**VIKING PREFERRED SERVICE**

# SERVICE BULLETINS

FROM #98-01

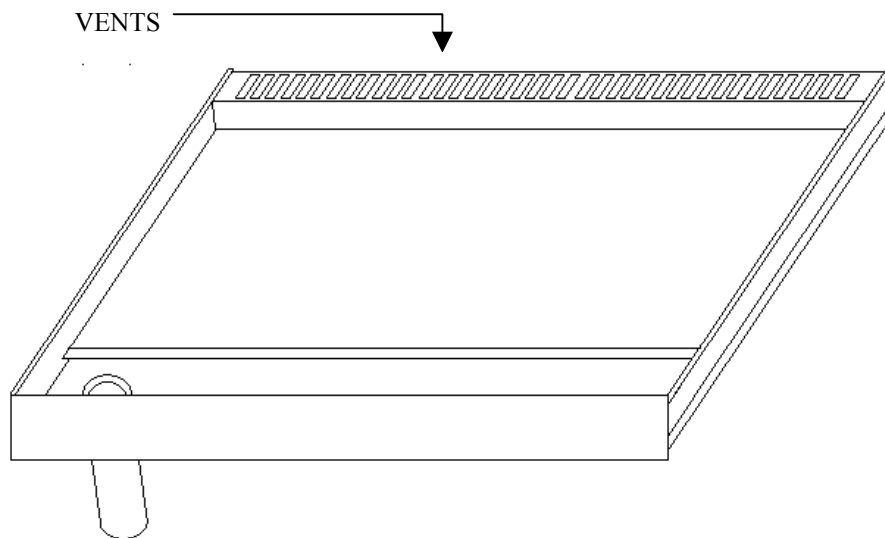
Flames lift on top burners when griddle is in use.

Remove and replace griddle with new 24" vented griddle (part #G3005641 24" vented griddle).

ILLUSTRATION #3

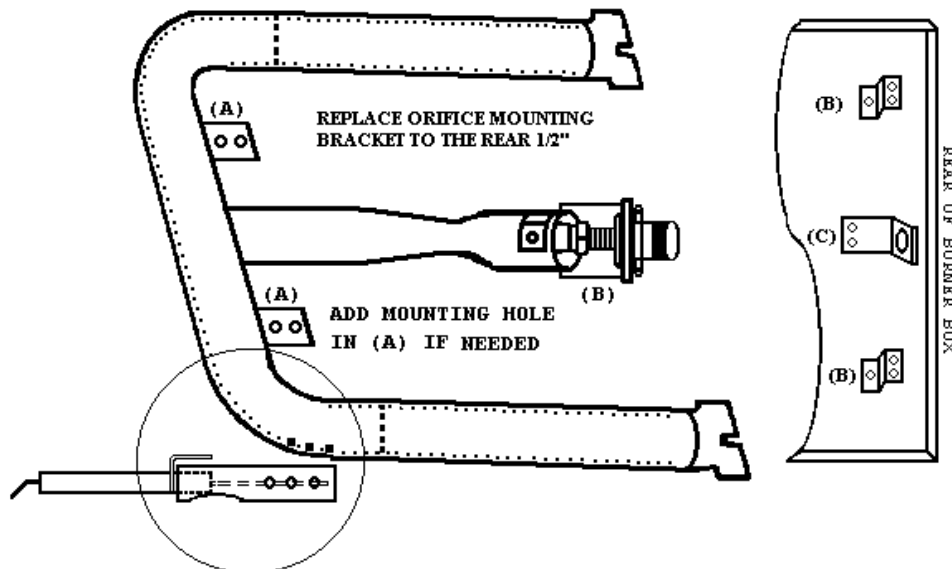
To Correct Burner Shut-down During Normal Operation.

- Correction:**
- (1). Replace the Orifice mounting bracket "C".
  - (2). Add another mounting hole in oven bottom for burner bracket "A".
  - (3) Add new Brackets "B" from kit.

Alignment of the igniter electrode in the blue tips of the inner cone at the three burner ports (located below the regular burner ports) will keep the gas valve open, preventing shutdown.

ILLUSTRATION #3

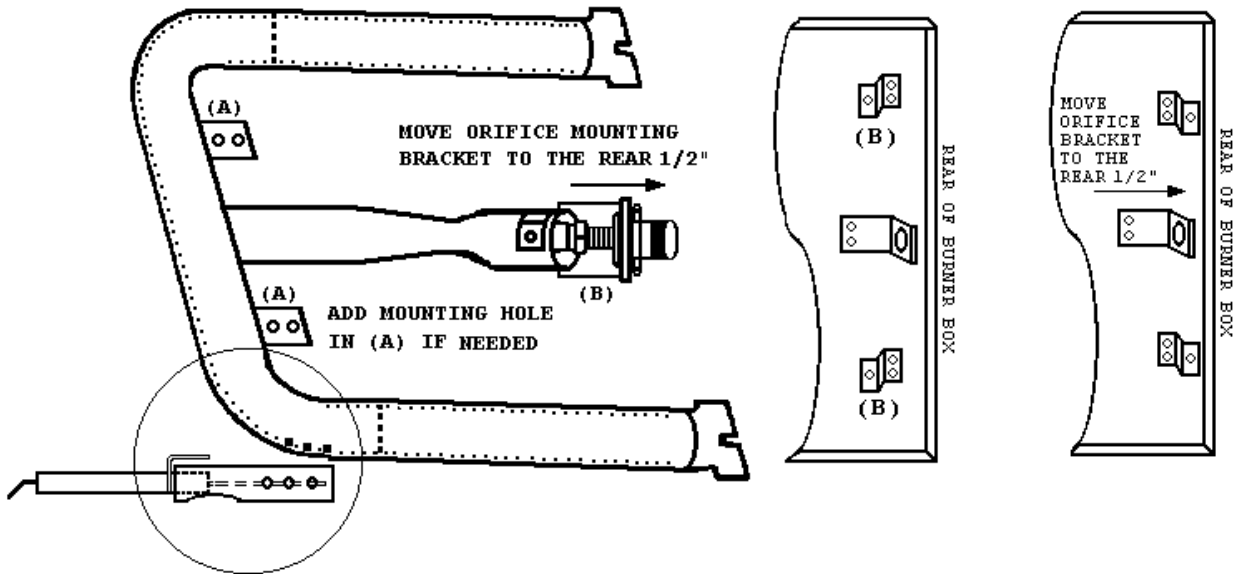
To Correct Burner Shut-down During Normal Operation.

- Correction:** (1). Reverse the burner mounting “Z” brackets (B).  
(2) Add another mounting hole in bottom of oven to mount bracket (A).

Alignment of the igniter electrode in the blue tips of the inner cone at the three burner ports (located below the regular burner ports) will keep the gas valve open, preventing shutdown.

ILLUSTRATION #3

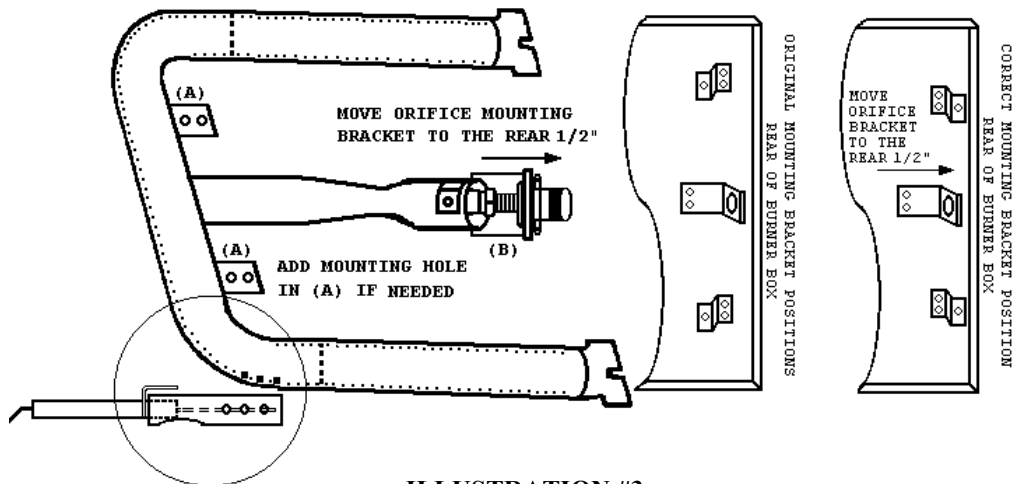
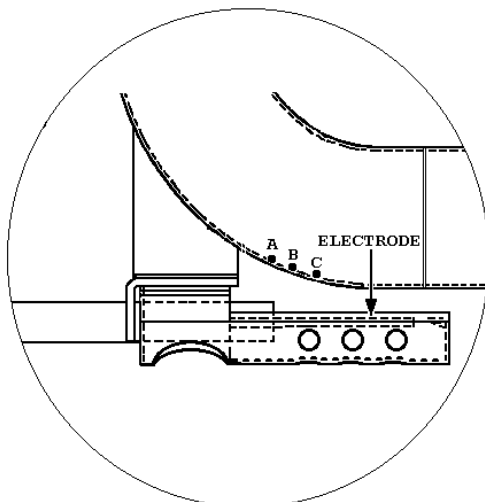
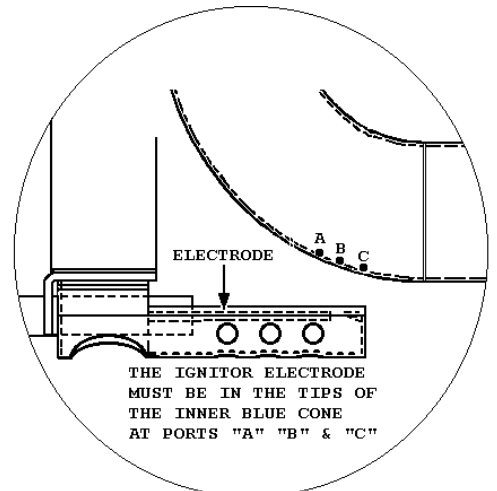
To Correct Burner Shut-down during Normal Operation.

- Correction:**
- (1) Inspect the position of the igniter electrode to the burner ports (A, B, & C). Illustration #1 is incorrect. Illustration #2 is the correct position.
  - (2) Reverse the burner mounting "Z" bracket (See Illustration #3 Below).
  - (3) Move the Orifice mounting bracket toward the rear 1/2" and remount.
  - (4) Add another mounting hole in bracket (A) if needed.

These corrections will move the burner onto the orifice hood for better gas/air adjustment. Alignment of the igniter electrode in the blue tips of the inner cone at the three burner ports (located below the regular burner ports) will keep the gas valve open, preventing shutdown.

**THE IGNITER ELECTRODE MUST BE IN THE TIPS OF THE INNER BLUE CONE AT PORTS : "A", "B" & "C"**

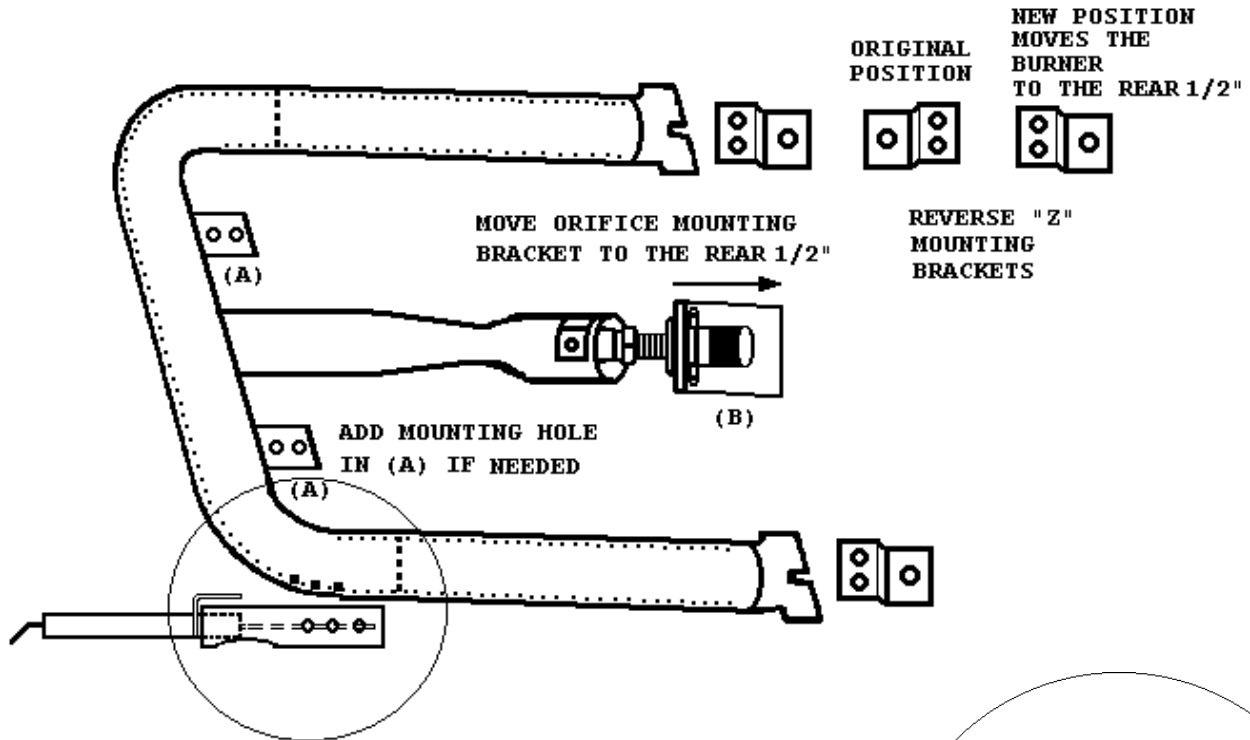
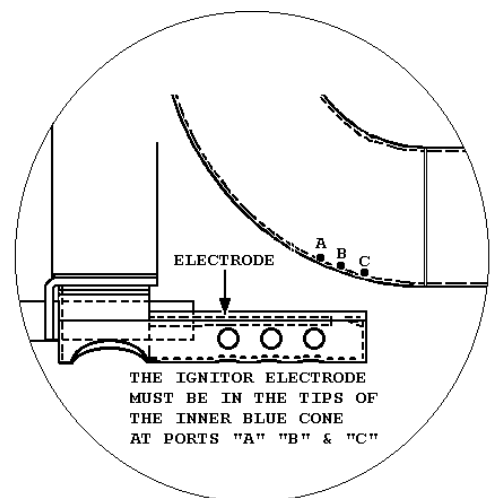
**Re:** To Correct Burner Shut-down during Normal Operation.

- Correction:**
- (1) Reverse the burner mounting "Z" bracket (See Illustration below).
  - (2) Move the Orifice mounting bracket toward the rear 1/2" and remount.
  - (3) Add another mounting hole in bracket (A) if needed.

**THE IGNITOR ELECTRODE MUST BE IN THE TIPS OF THE INNER BLUE CONE AT PORTS "A", "B" & "C".**

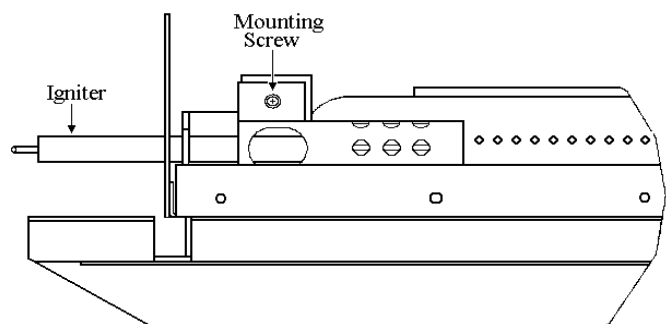
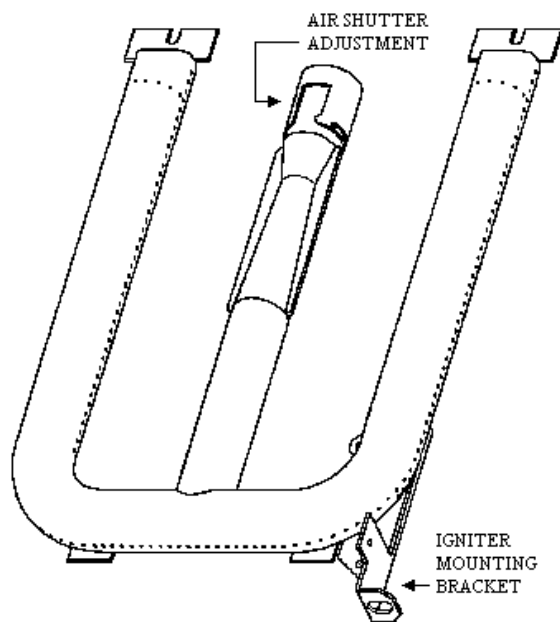
**Complaint:** Burner shutdown during normal bake operation and self-clean operation.

**Correction:** Install new Burner with welded igniter bracket:

### VGSC306 (30") Part # G5008216 8" Bake Burner Kit

1. Remove oven racks and rack supports.
2. Remove oven bottom pan assembly.
3. Remove burner cover.
4. Remove and save igniter for later installation.
5. Install new burner (with welded igniter bracket).
6. Re-install the saved igniter.
7. Replace burner cover and oven bottom pan assembly to check and adjust the air/gas mixture.

Re: VGSC366 36" W. Gas Self-Clean Range

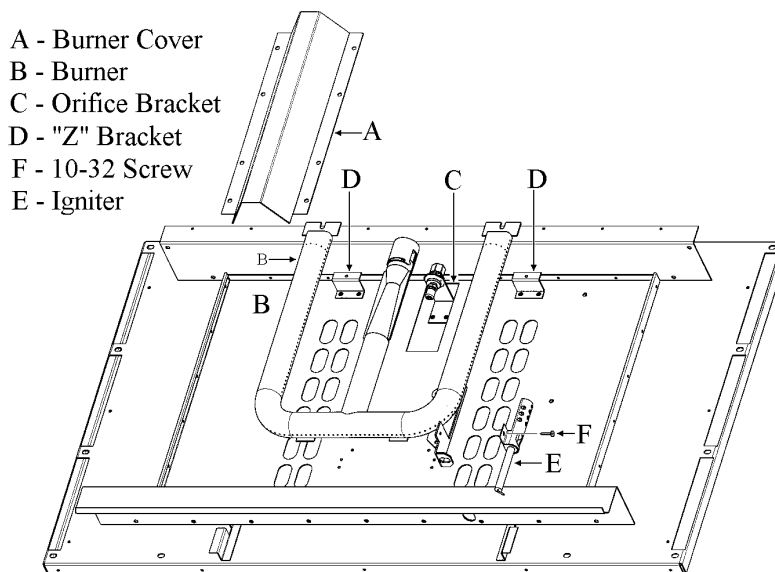
**Complaint:** Burner shutdown during normal bake operation and self-clean operation.

**Correction:** Install new burner with welded igniter bracket:

1. Remove racks and rack supports.
2. Remove bottom pan assembly.
3. Remove burner cover (A).
4. Remove old burner (B).
5. Remove igniter and igniter bracket (E) - (retain igniter for later use.)
6. Remove (2) rear "Z" brackets (D).
7. Remove orifice bracket (C)
8. Install new orifice bracket.
9. Install (2) new "Z" brackets.
10. Place new burner in position (**DO NOT MOUNT**).
11. Install igniter on burner using supplied SS 10-32 screw (F)
12. Mount rear of burner to "Z" brackets.
13. Drill 2 new holes in burner bottom for front brackets.
14. Re-install burner cover (A), bottom pan assembly, rack supports and racks.

**Service Bulletin:2003-1-CE**

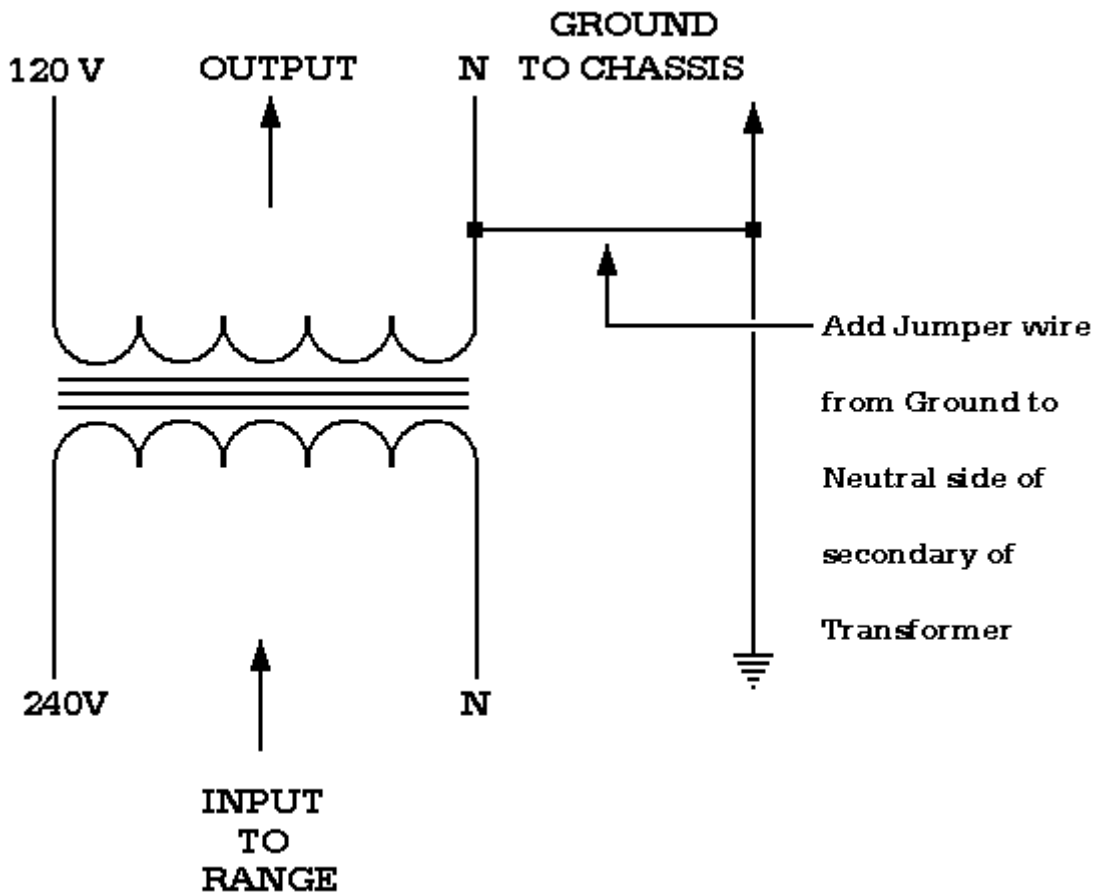
**Subject: Ghost Arching**

**Correction: Add jumper wire from ground to Neutral side of Secondary of Transformer (See Diagram below).**

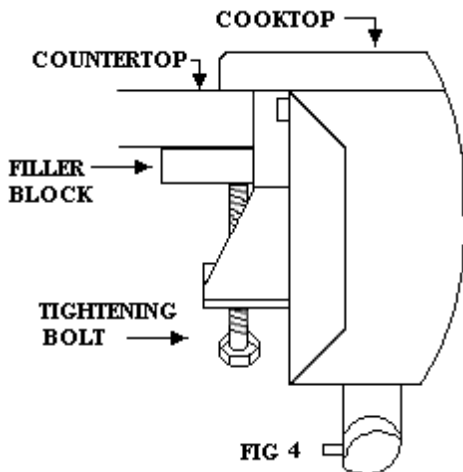
**NOTE:** If countertop is less than 1 1/2" (3.8cm) thick a filler block will have to be used for bolt to push against. (See Figure 4)

- There must be a 1" (2.5cm) clearance under counter on all 4 sides of the cooktop for pull down brackets to be attached.

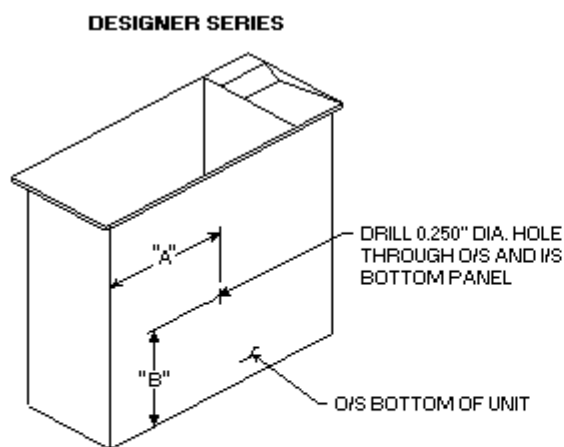
**Re: Field repair for warped inside bottom panels on Warming Drawer, which causes the drawer to rub the thermal bulb bracket when opening and/or closing.**

1. Disconnect the electrical power from the unit and remove from the cabinet.
2. Remove the door and/or pan assemblies.
3. Drill 0.250-diameter hole through the outside and inside bottom panel (see the attached drawing for dimensions).
4. Insert a #10-24 x 0.750" machine screw from the bottom of the unit and use a #10-24 nut on the inside of the unit to pull the two panels together.
5. Install the unit in cabinet and connect electrical power.

MODEL	"A"	"B"
DEWD170	11"	8"
DEWD100	12 1/2"	8"

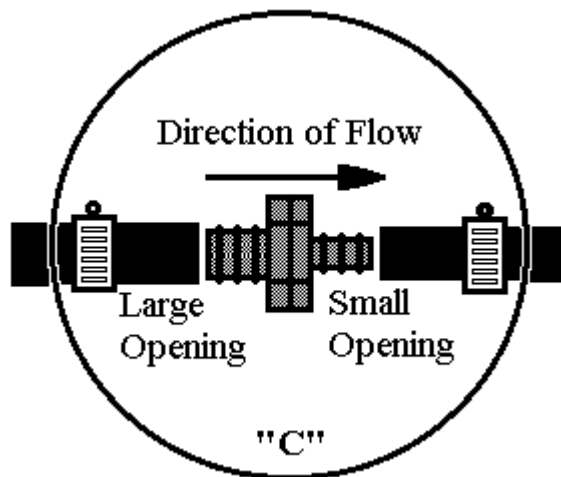
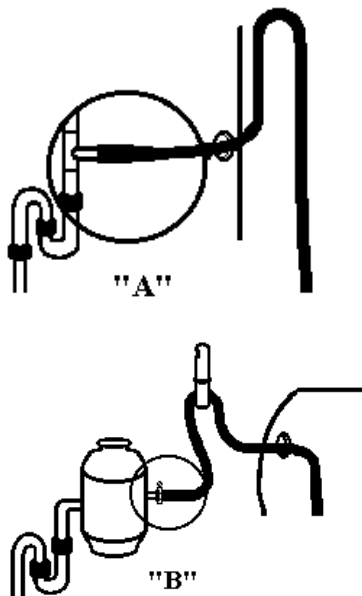
To eliminate the water from back-flushing into the dishwasher from the drain hose attached to the plumbing beneath the sink, the "Check Valve Kit" will need to be installed.

**The "Check Valve Kit" number is PD140027. The kit consists of:**

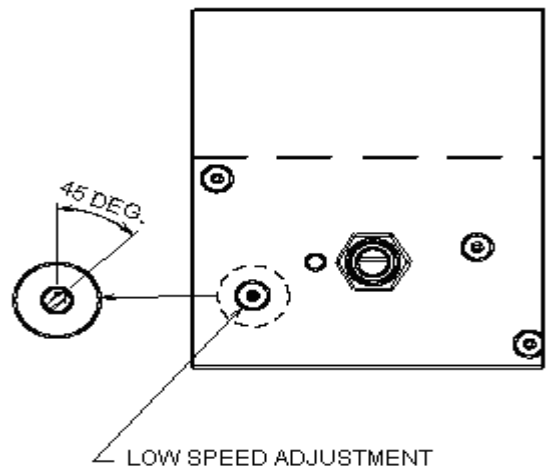
**Complaint: Fan will not start with the control in the low position.**

1. Turn Arrow CLOCKWISE to INCREASE voltage to 58VAC on low speed setting.
2. FACTORY SETTING is 58VOLTS ( $\pm 3$  VOLTS) or ARROW POINTING TO 45° CLOCKWISE ROM THE 12 O'CLOCK POSITION. BLOWER MUST BE PLUGGED IN AND RUNNING WHEN VOLTAGE IS MEASURED.

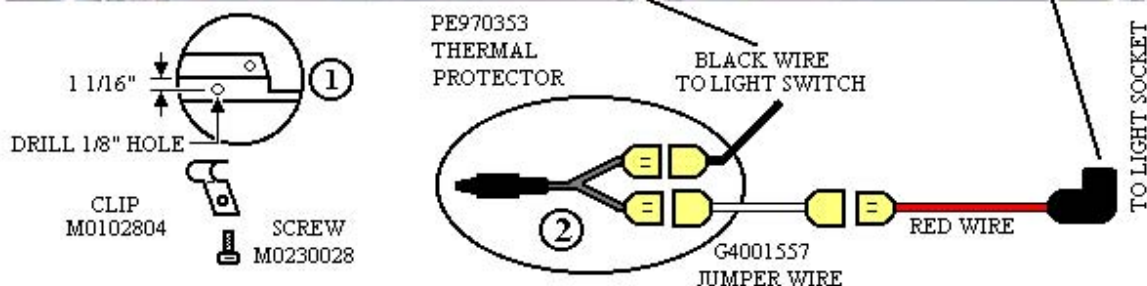
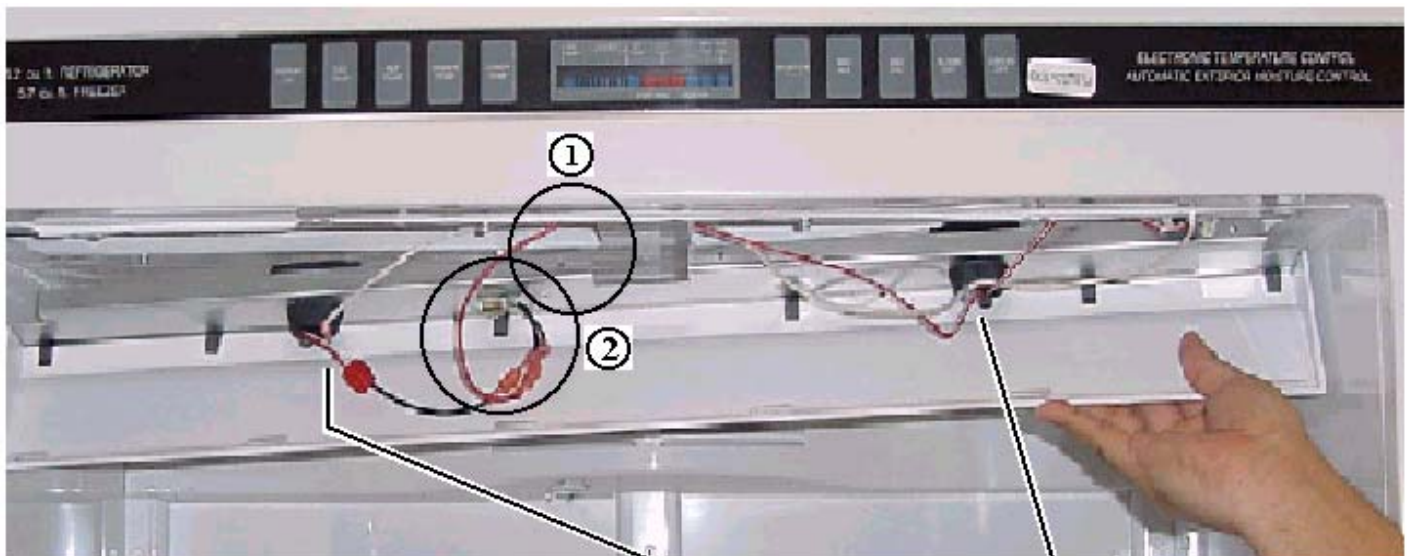
**Models affected:** \*\*\*\*362/482 Bottom Mount and Side-by-Side refrigerator/freezers  
 \*\*\*\*363/483 Bottom Mount and Side-by-Side refrigerator/freezers (products manufactured before 05/09/02. Light Thermal Kit installed in products manufactured on/after 05/09/02)

**Correction:** Install Light Thermal Kit (#G5098071) as shown in illustrations below:

1. Remove the light shield to expose the wiring to the light socket and light switch.
2. Drill a mounting hole for the Bracket (clip) as shown in ①
3. Install Thermal Protector using the Bracket (clip) and Screw provided.
4. Connect the Thermal Protector between the light socket and the light switch as shown below. ②

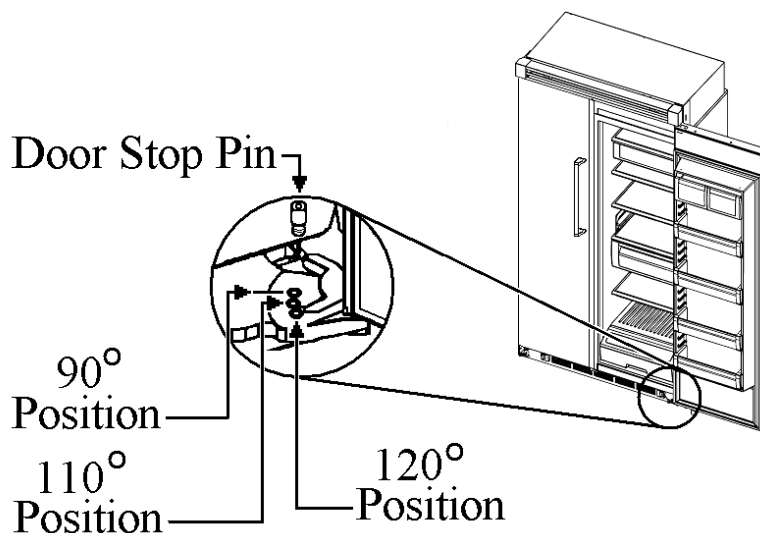
Complaint: Refrigerator door not closing properly

Cause: Return Arm interferes with the Leveling Let Block

## MODIFICATION TO SC30"41"53" GRILL CARTS

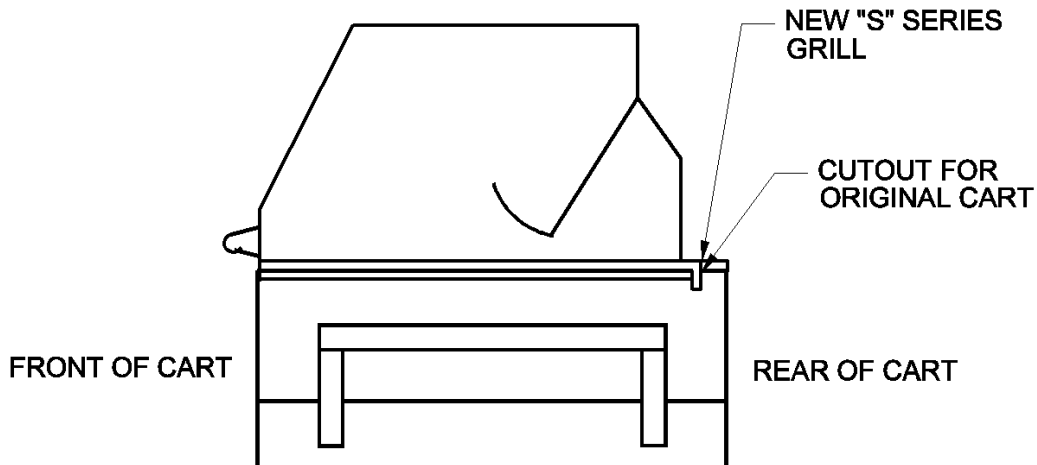
In order to improve the stability of grill/cart installations, modifications have been made to the "S" Series grill and cart. Extra support has been added to the outside trim of the grill head to provide more stability around the perimeter of the unit. A slot has been added to the cart to provide a positive fit/location for the grill head. This gives the grill head a more secure seat and provides solid support.

**IMPORTANT:** Both grills (non-"S" model and "S" model) will fit on the new "S" Series carts; the "S" Series grills (manufactured before 3/05/99) will fit non-"S" carts when modified as illustrated below.
